PROPOSED STORM SEWER TO SERVE TRAVIS ADDITION, WICHITA, KS. CITY PROJ.

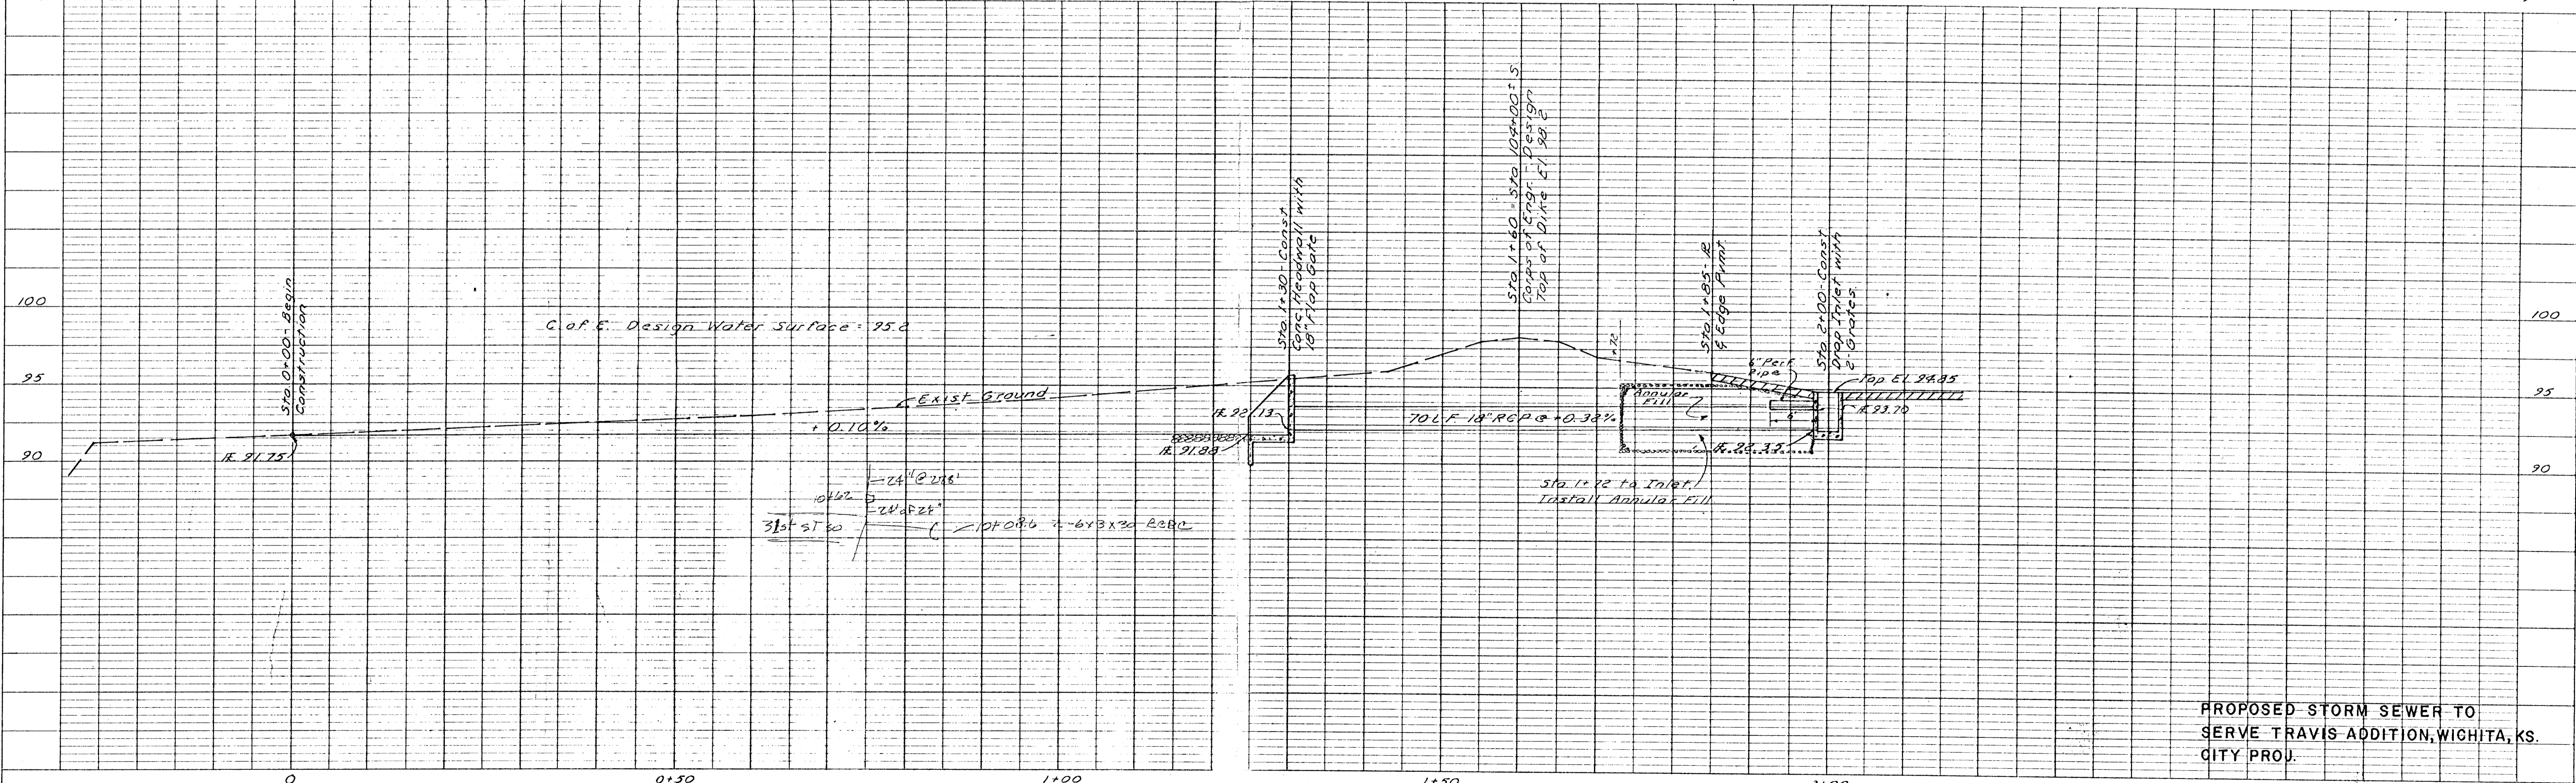
- 1) Flap Gate + Sluice Gate Req.
- 2) Approval from Corpal Eng. Req'd.
